ADDENDUM NO. 1

December 8, 2025

Ceres Hill MP 0.79 Bridge Retrofit Project
Federal Aid Project No. BHOS-2021(079)
Federal Aid Contract No. TA8347
CRP 2204

REFERENCE SHEET NO. S06

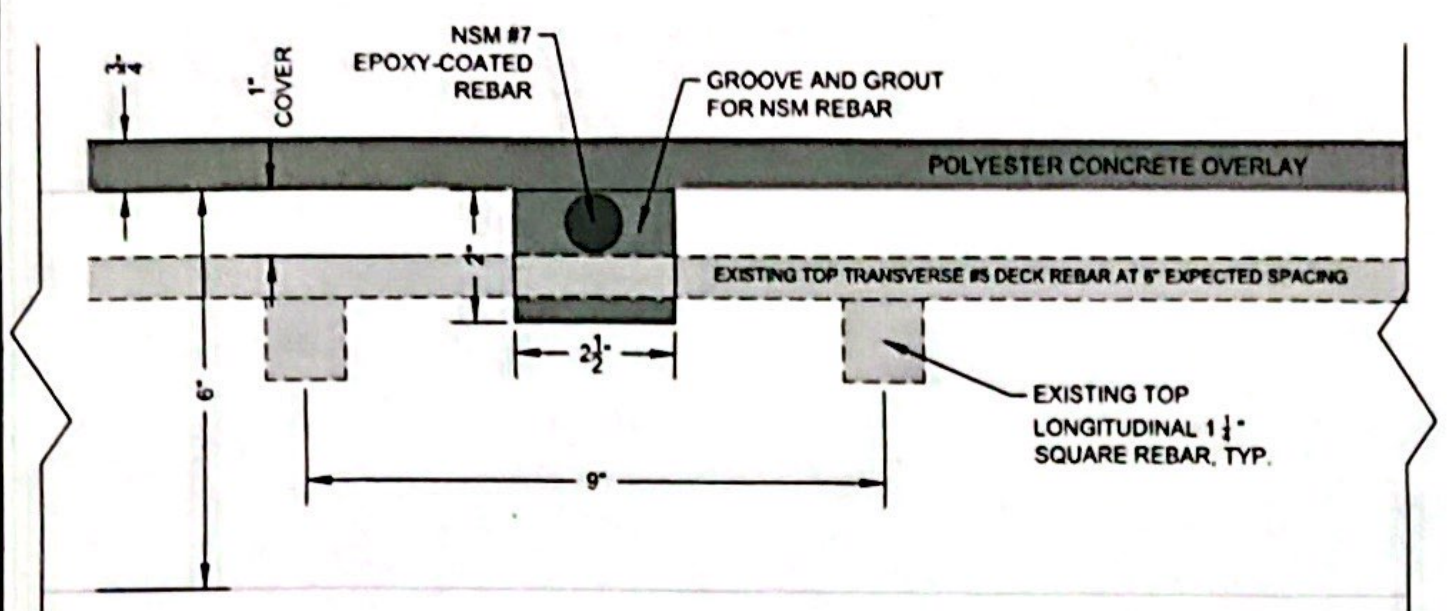
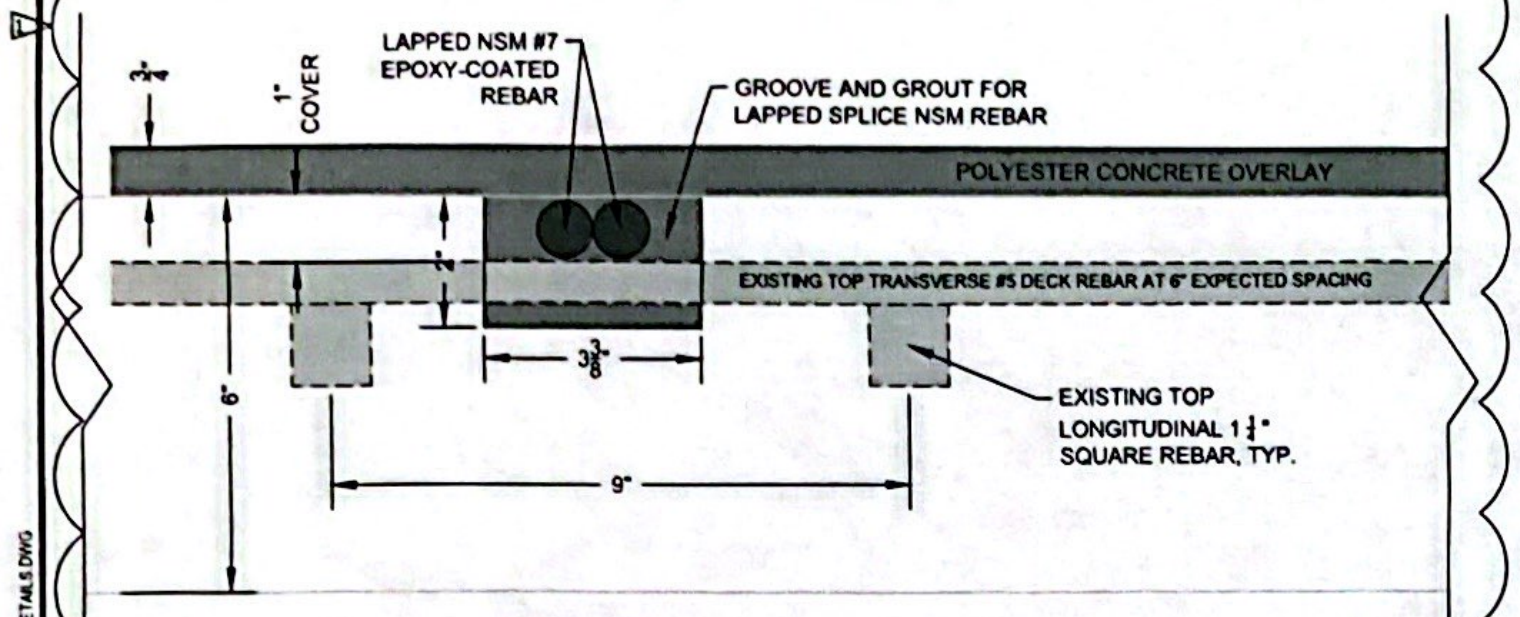
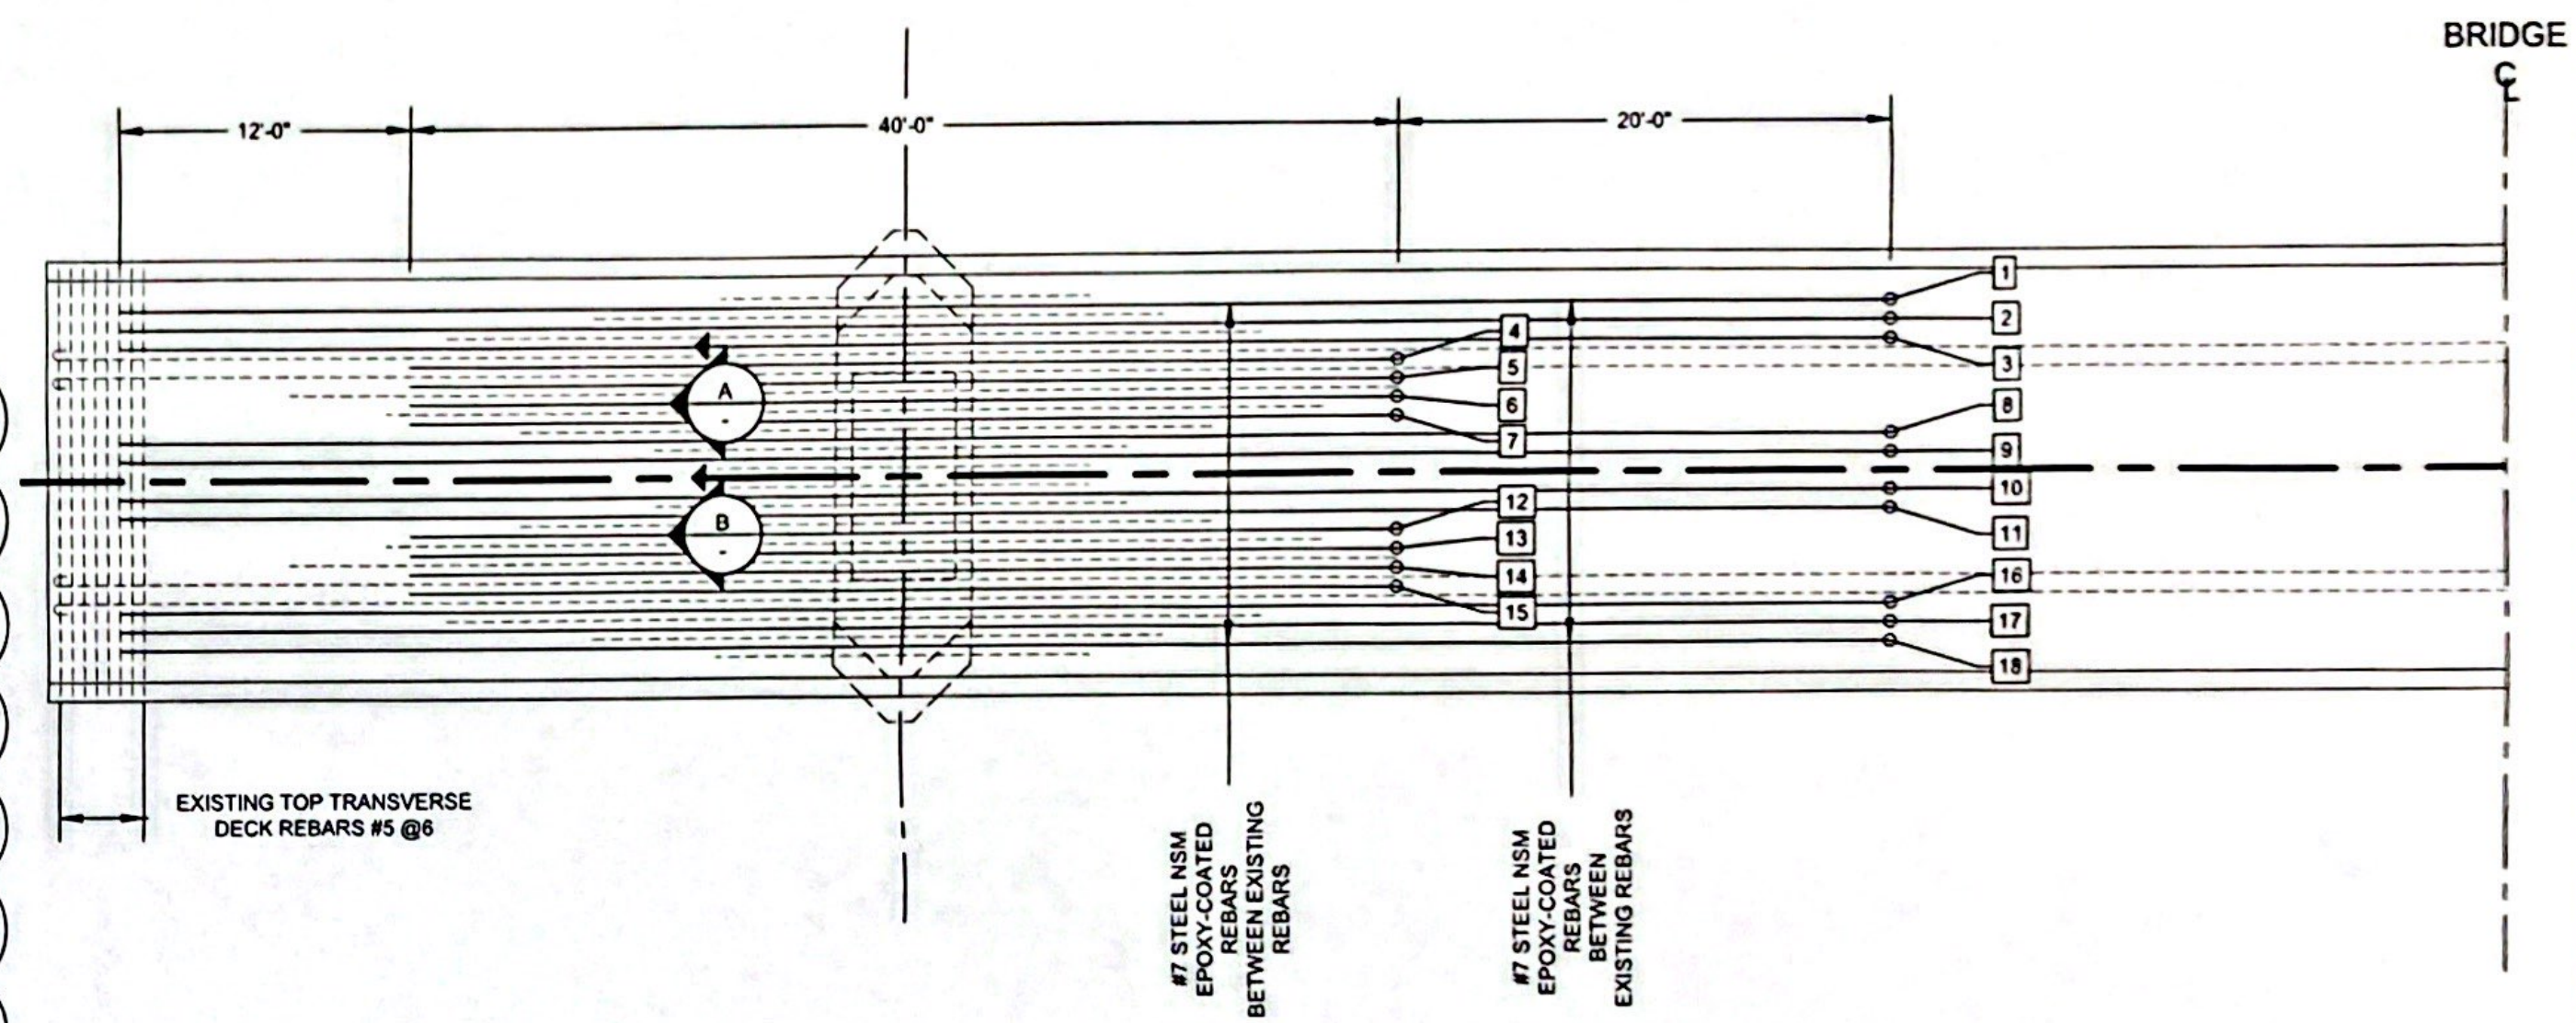
Appendix F
Replace Contract Drawing Sheet S06 and S07 with the included Drawing Sheets S06 and S07.

NO.	DATE	REVISION
▷	12/8/2025	NSM DETAIL REVISION

NOTE: LAP SPLICE LENGTH FOR #7 NSM REBAR = 80"

SEQUENCE OF GROOVING AND MOUNTING TOP REBARS OVER EACH PIER	
STAGE	GROOVED AND MOUNTED TOP REBARS
1	1, 2, 3, 16, 17, 18
2	8, 9, 10, 11
3	4, 5, 6, 7, 12, 13, 14, 15

REFERENCE SHEET NO. S07

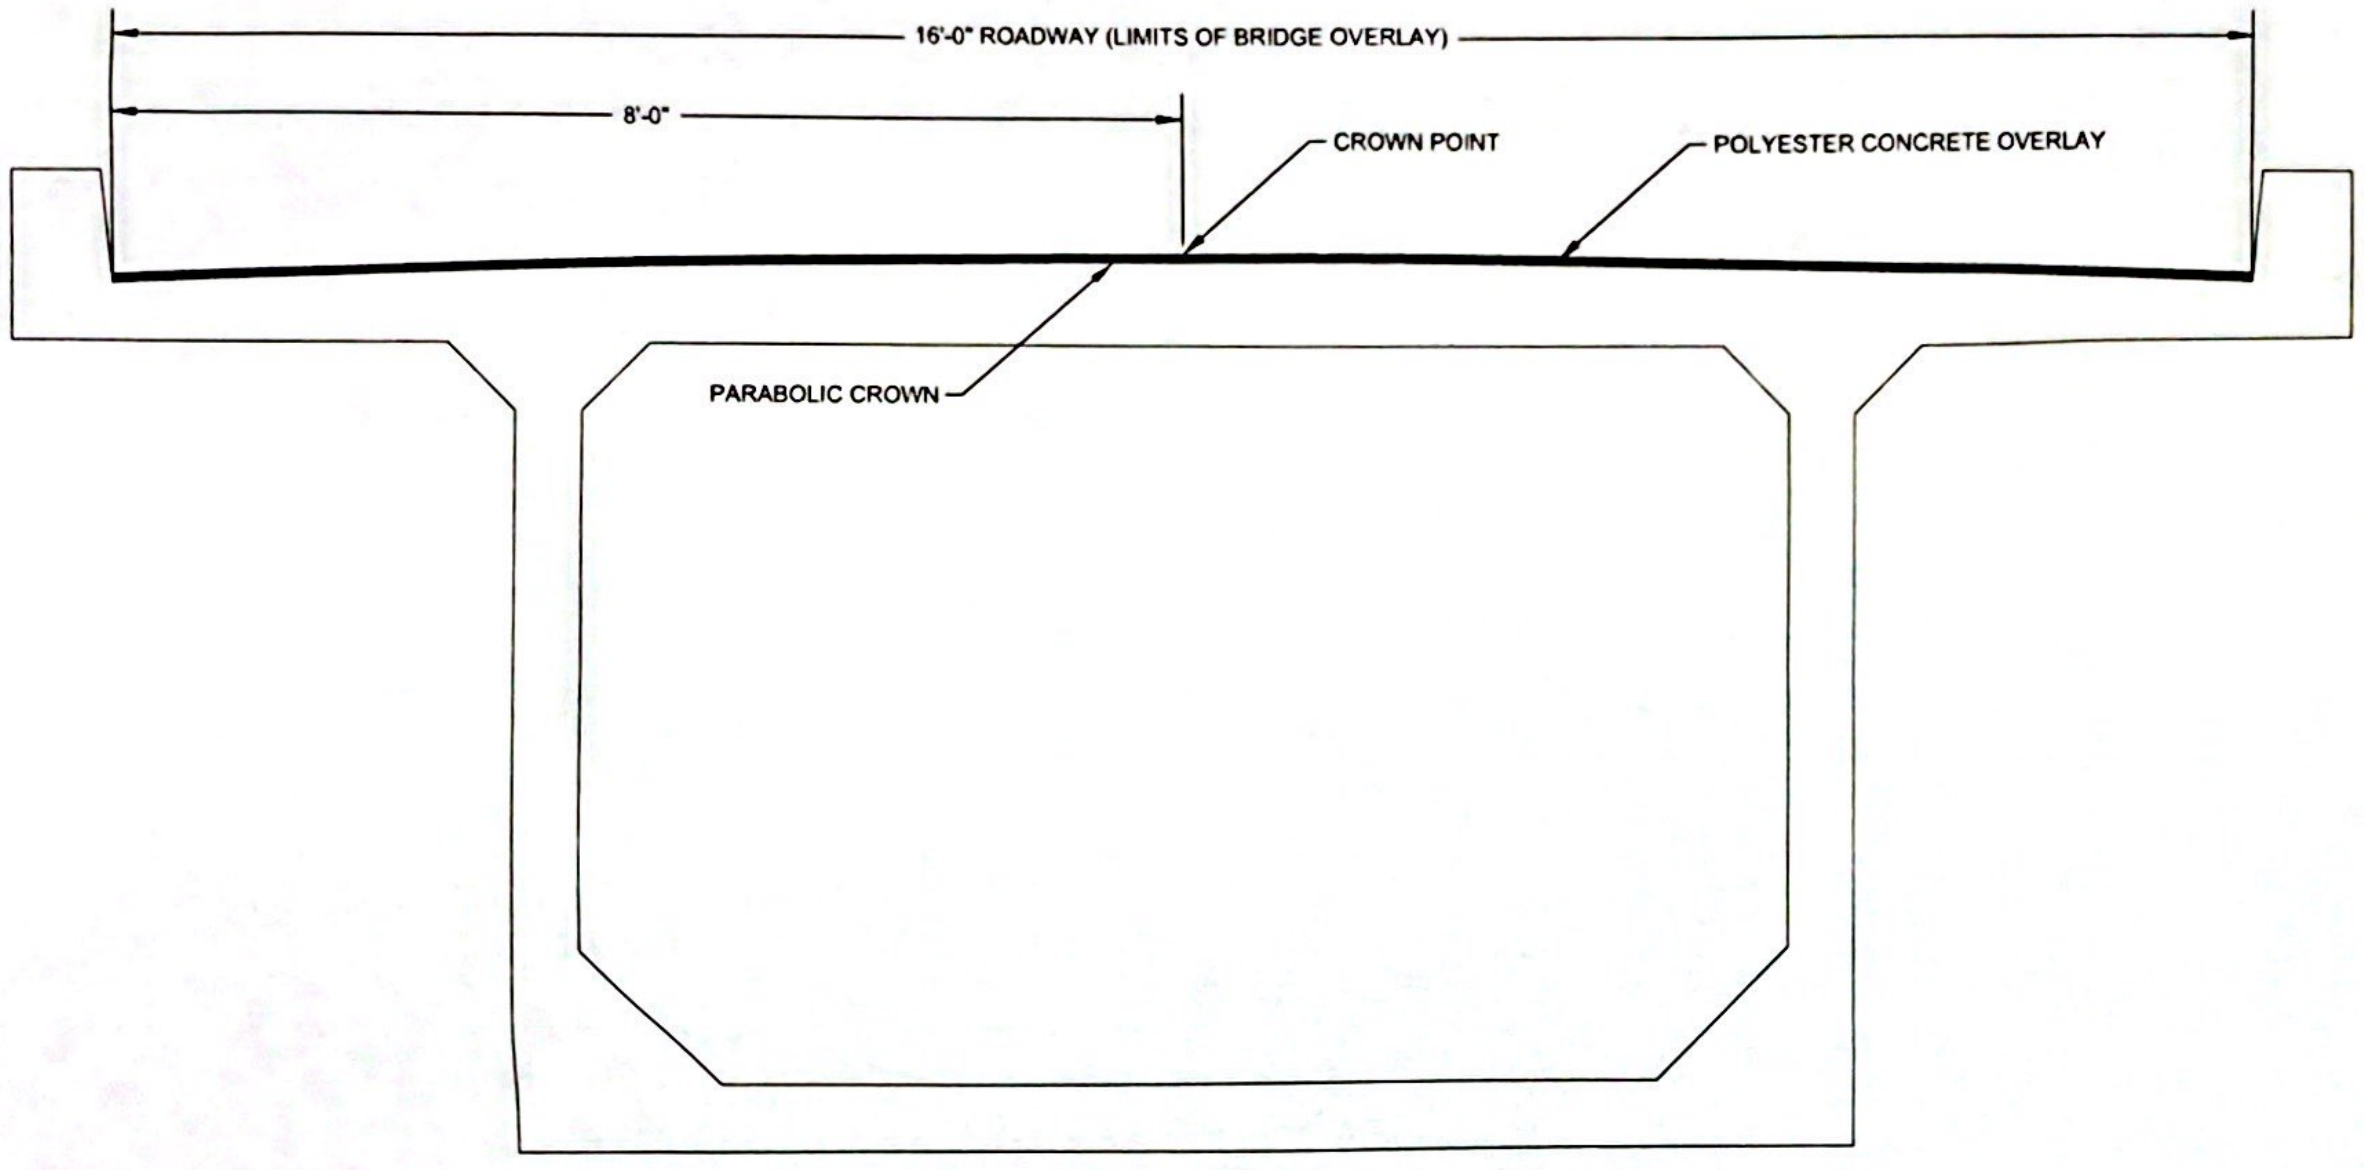
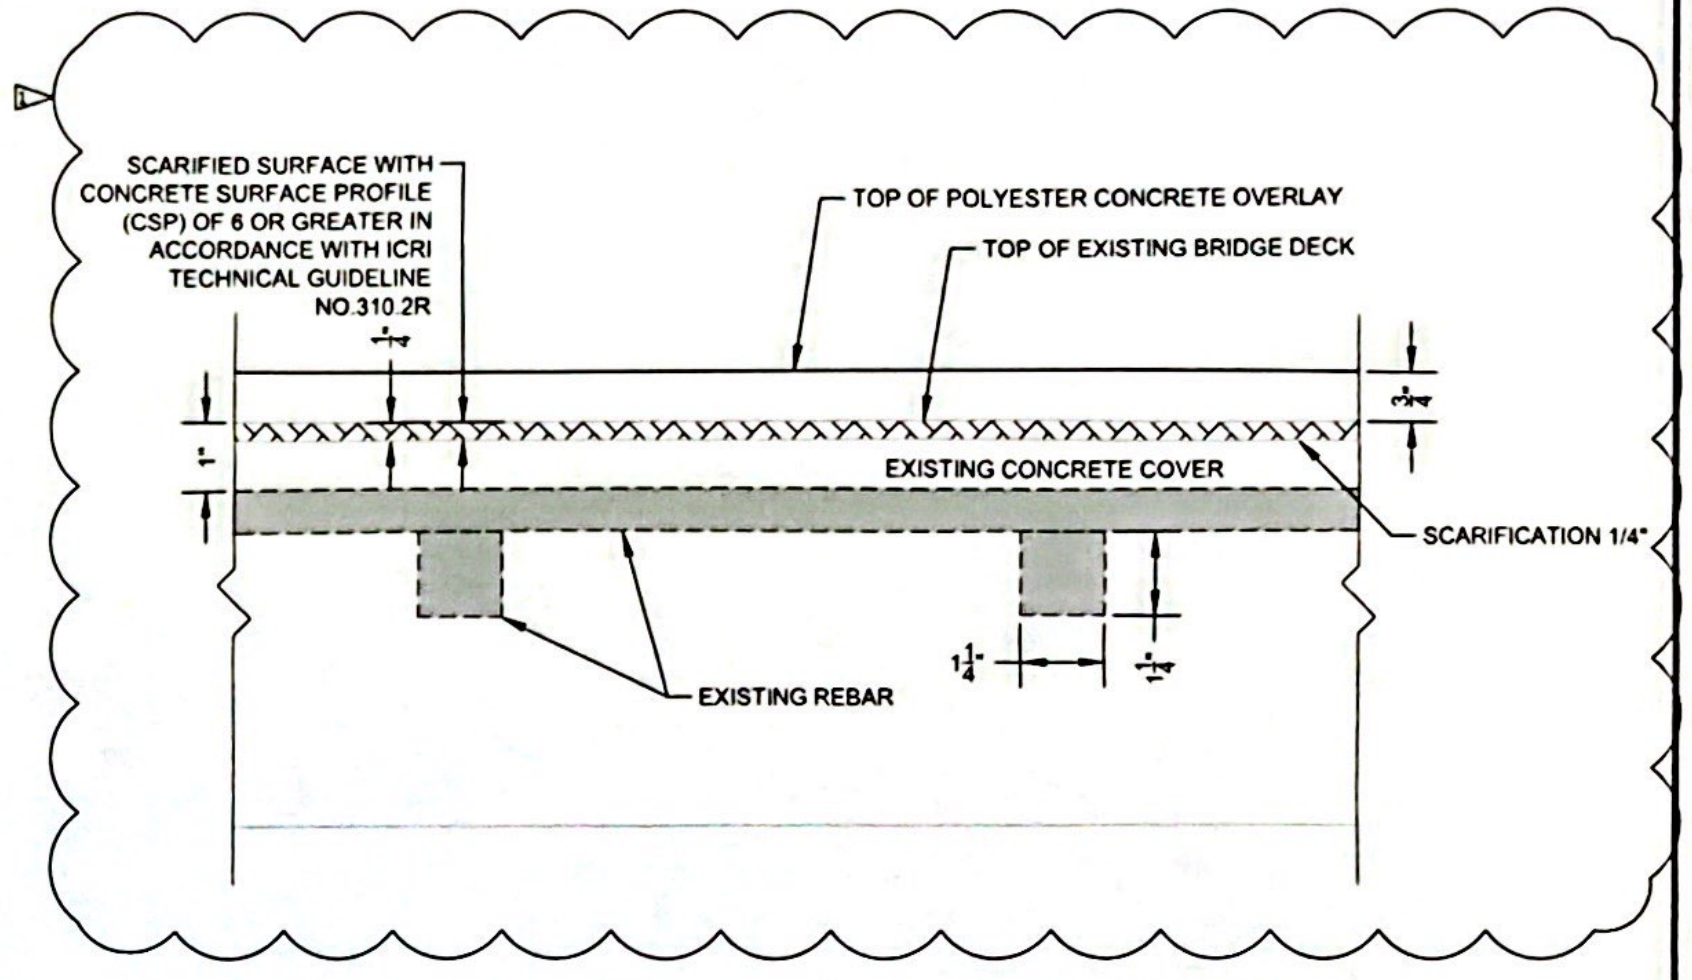
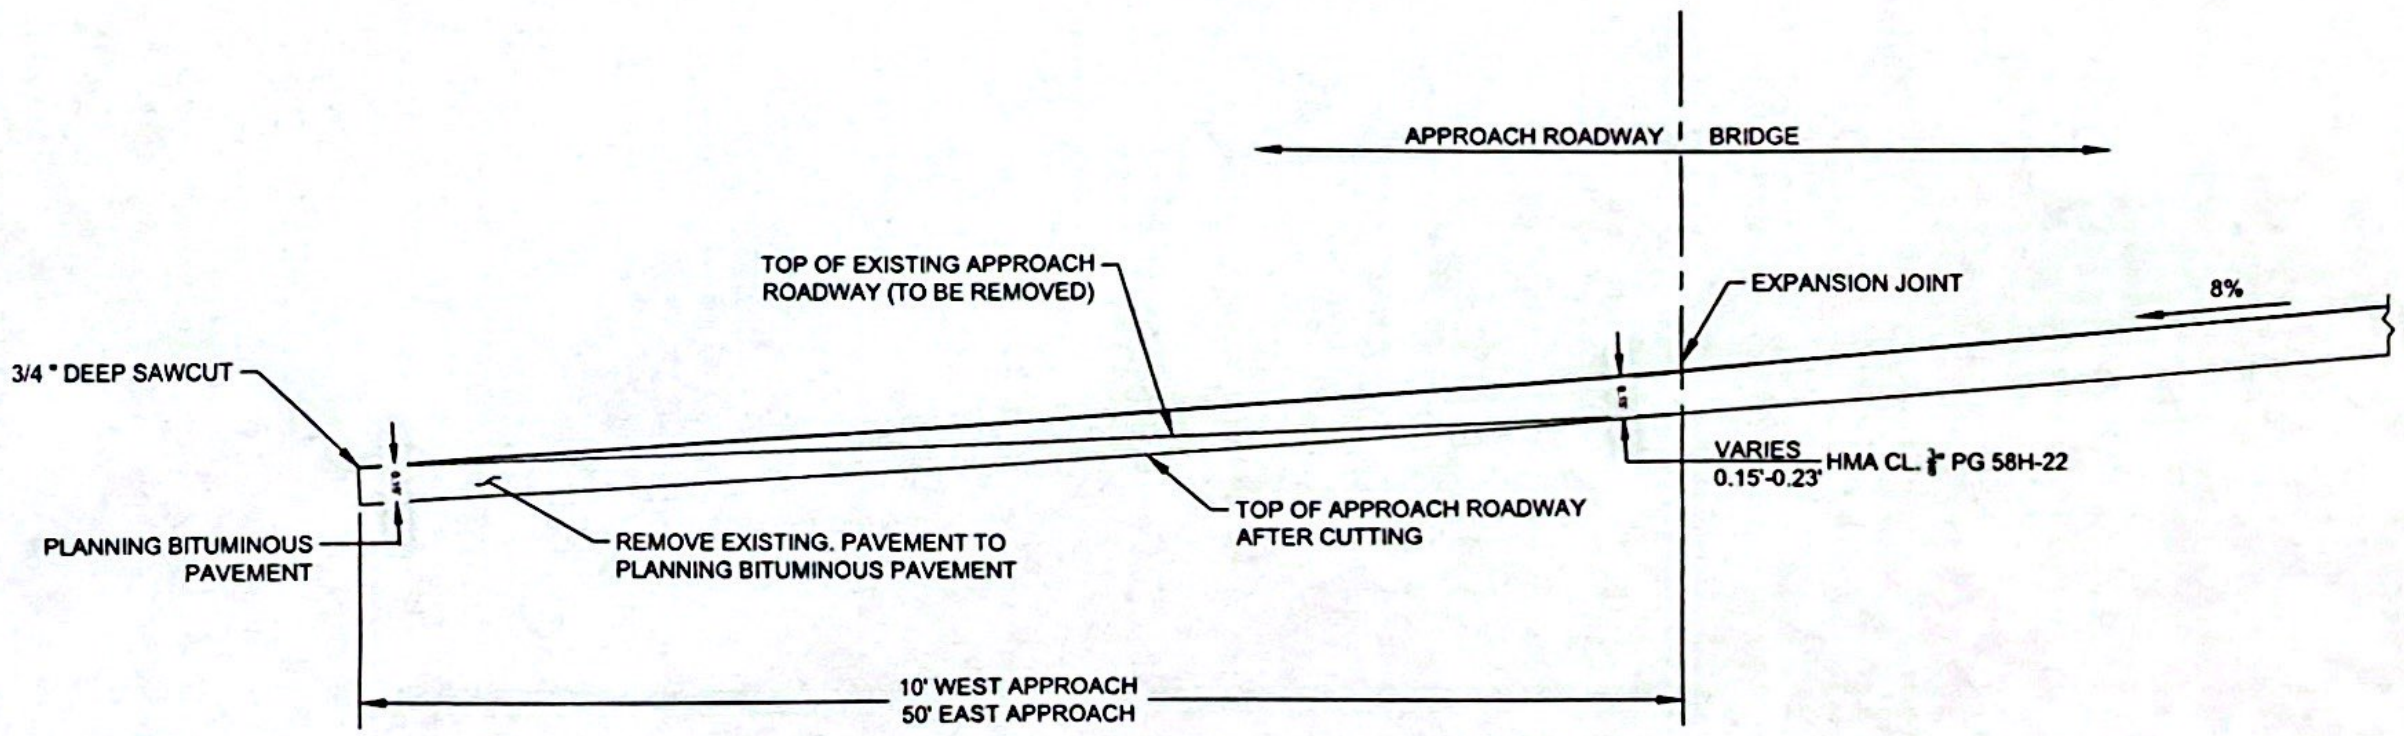
NO.	DATE	REVISION
1	12/8/2025	NSM DETAIL REVISION

6-09.3(10)C Minimum Polyester Concrete Overlay Thickness, replace with the following: The minimum thickness of polyester concrete overlay shall be 1.0 inches, except as otherwise shown in the Plans or adjusted by the Engineer. with The minimum thickness of polyester concrete overlay shall be 0.75 inches, except as otherwise shown in the Plans or adjusted by the Engineer.
